### PRODUCT/PROCESS CHANGE NOTICE (PCN)

PCN #: <b>TB0711-02</b>	DATE: <b>12/12/2007</b>	MEANS OF DISTINGUISHING CHANGED DEVICES: <input type="checkbox"/> Product Mark <input type="checkbox"/> Back Mark <input type="checkbox"/> Date Code <input checked="" type="checkbox"/> Other
Product Affected: <b>14 mm x 14 mm PQFP 52L and 64L shipped in tray</b>		
Date Effective: <b>3/12/2008</b>		Supplier part# on side of tray

### ATTACHMENT I - PCN #: TB0711-02

**Detail of Change:** This notification is to advise our customers that IDT has qualified new shipping trays for 14 mm x 14 mm PQFP 52L and 64L products.

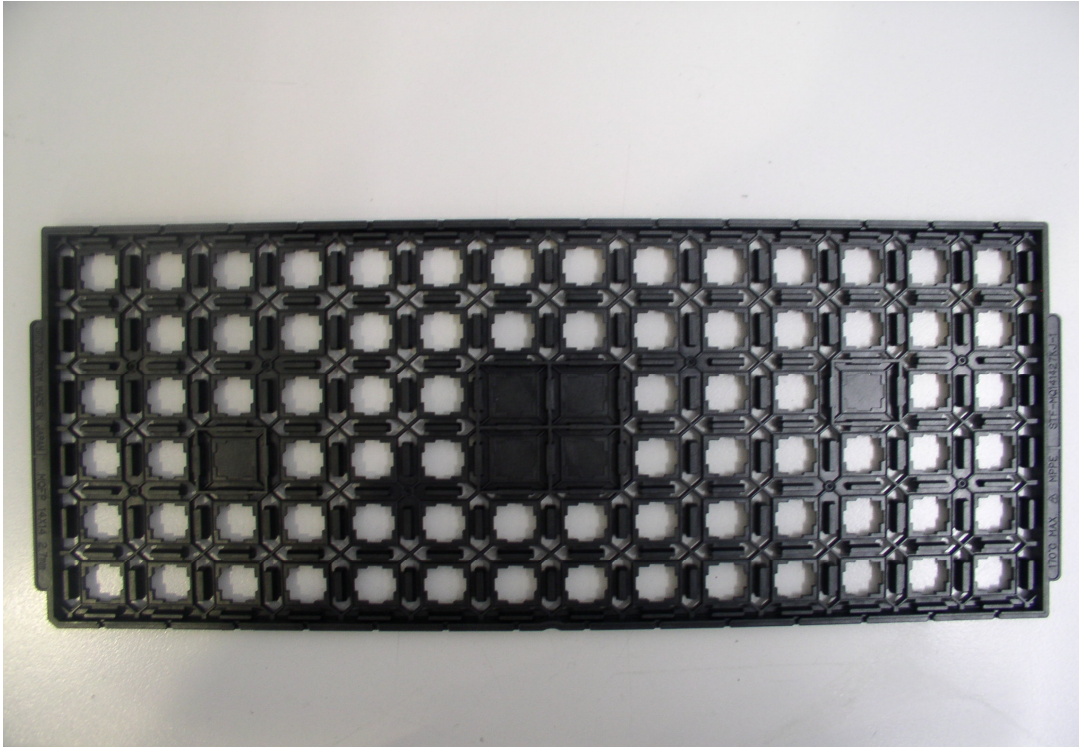
There is no change to the number of units per tray and tray dimensions but changes to the tray withstand temperature.

Description	Existing Shipping Tray	New Shipping Tray
Supplier	Shinon	NK Tech
Supplier Part Number	STF-MQ141427LD-1	TMHT-061402-02
IDT Part Number	P7-148-000	P7-229-000
Tray Matrix	6 X 14	6 X 14
Qty per Tray	84 units	84 units
Rating Temperature	150°C	135°C
Tray Material	PPE + CF	PPE + CF
Pocket Size (WxL)	13.83 X 13.83 +/- 0.13 mm	13.92 X 13.92 +/- 0.07 mm
Tray Drawing Number	MSC-1717	MSC-5758

TOLERANCES UNLESS OTHERWISE SPECIFIED		DECIMALS		ANGLE	
XXX ±.13		XX ±.13		X ±.13	
APPROVALS		DATE			
DRAWN				TITLE:	
CHECKED				DN/DNG 52/64	
				SHIPPING TRAY	
STOCK NO.		DRAWING NO.		SCALE	
P7-148-000		MSC-1717		N/A	
DO NOT SCALE DRAWING		SHEET 1 OF 2		REV	
				B

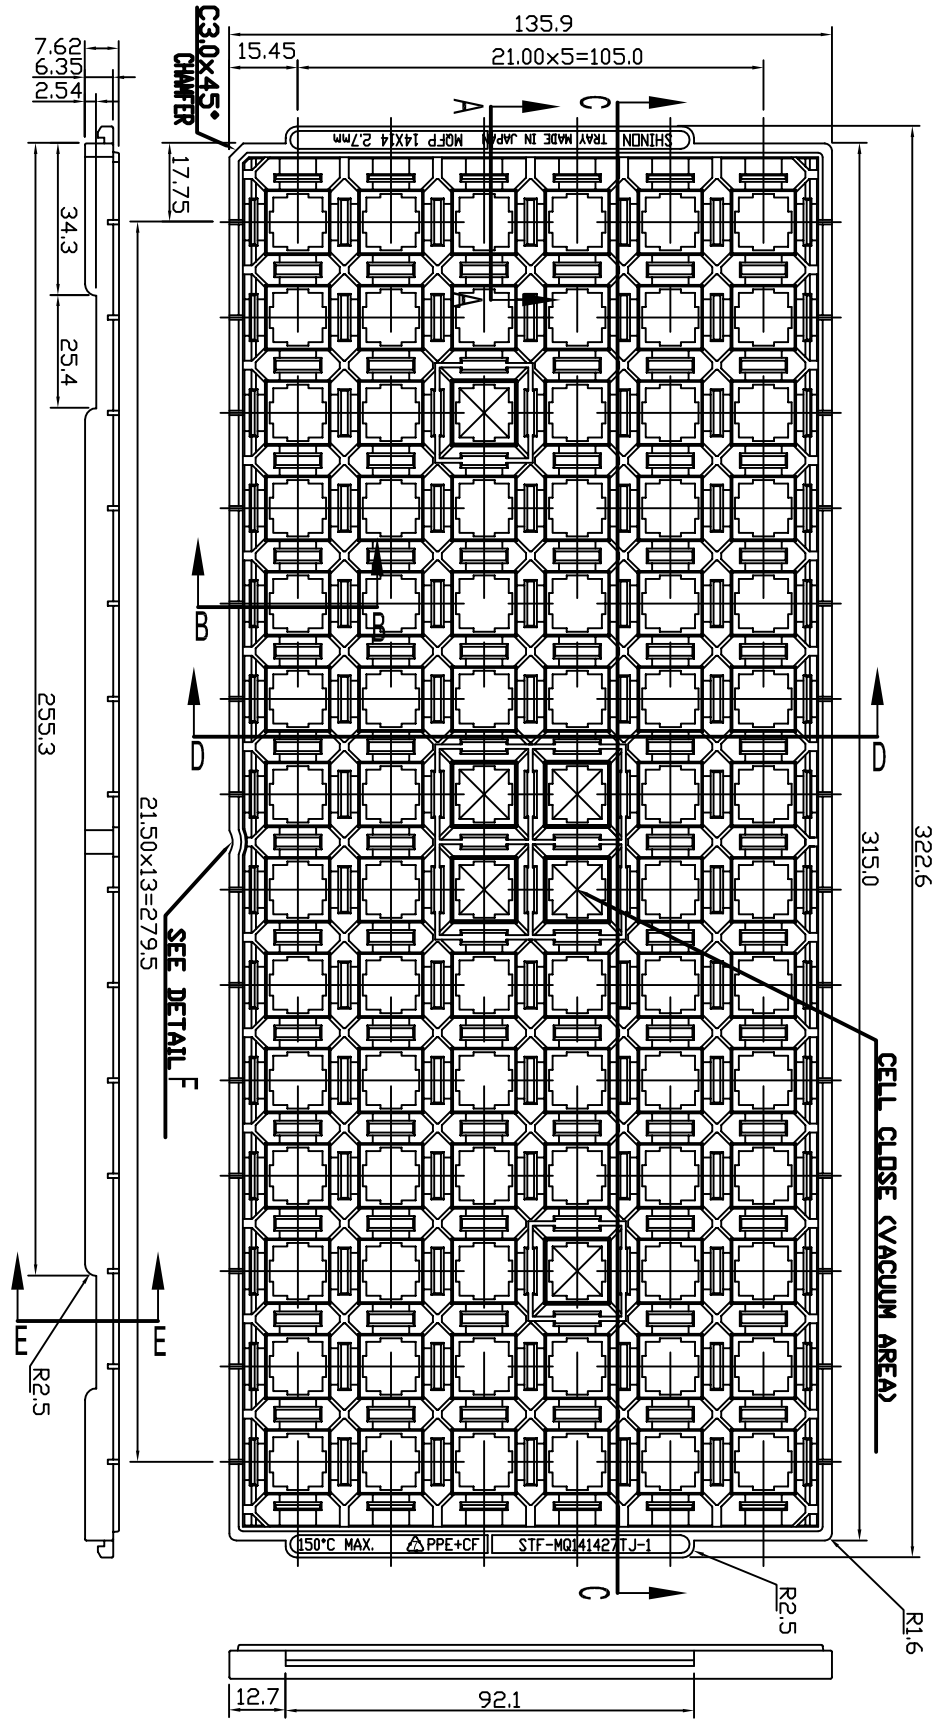
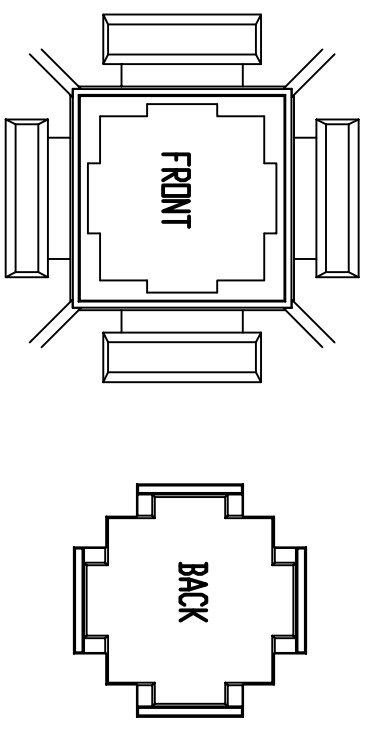
Existing Shipping Tray

TOLERANCES UNLESS OTHERWISE SPECIFIED		DECIMAL		ANGLE	
.X		±.25		±.5°	
.XX		±.13			
.XXX		±.13			
APPROVALS	DATE	www.IDT.com			
DRAWN		TITLE: DN/DNG 52/64 SHIPPING TRAY			
CHECKED		STOCK NO. P7-229-0001 MSC-5758			
		DRAWING NO. 00			
FILE: MSCI7011		DO NOT SCALE DRAWING SHEET 1 OF 4

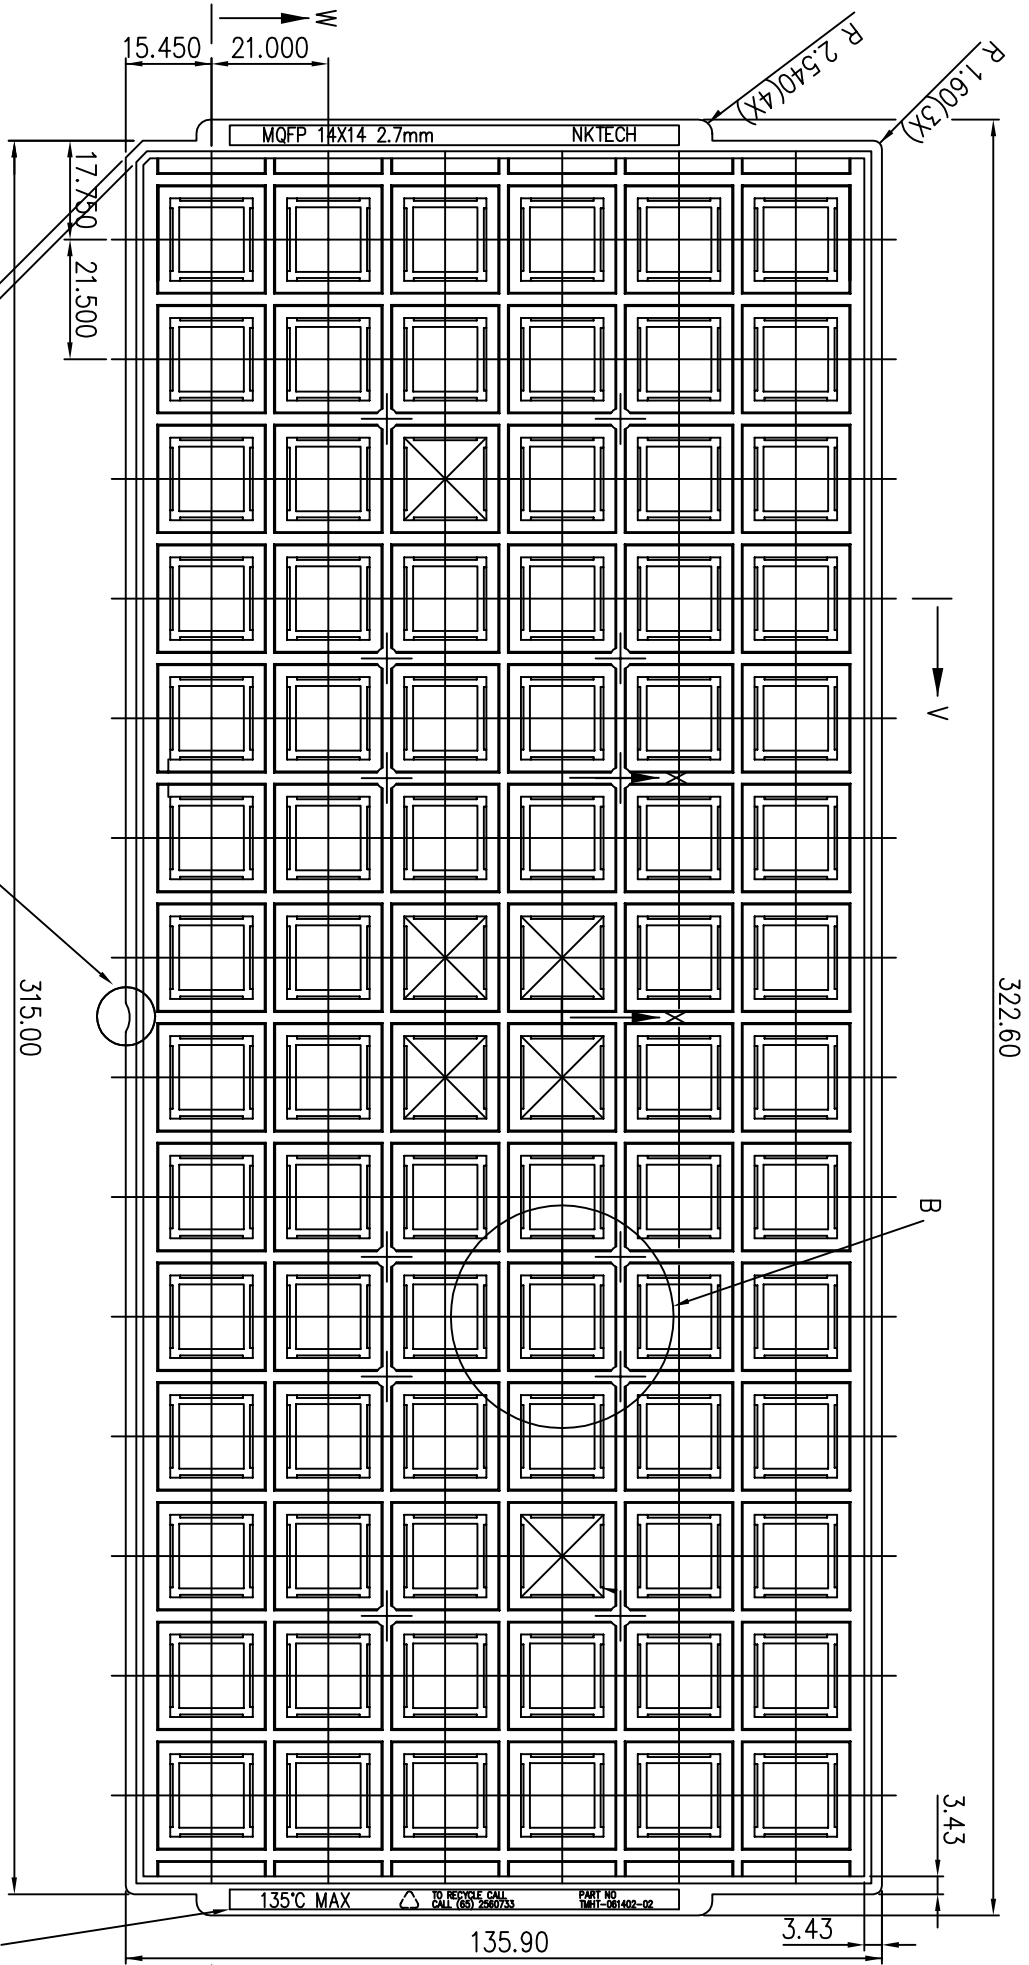
New Shipping Tray

- NOTES : (UNLESS OTHERWISE SPECIFIED)
1. MATERIAL : PPE+CF (BLACK)
  2. ALL DIMENSIONS ARE IN mm.
  3. TEMPERATURE : 135°C MAX
  4. ESD SURFACE RESISTIVITY SHALL CONFORM TO IDT SPEC MSA-3032.
  5. NEPTUNE PART NUMBER : TMHT-061402-02
  6. NUMBER OF POCKET : 6 X 14 = 84 POCKETS
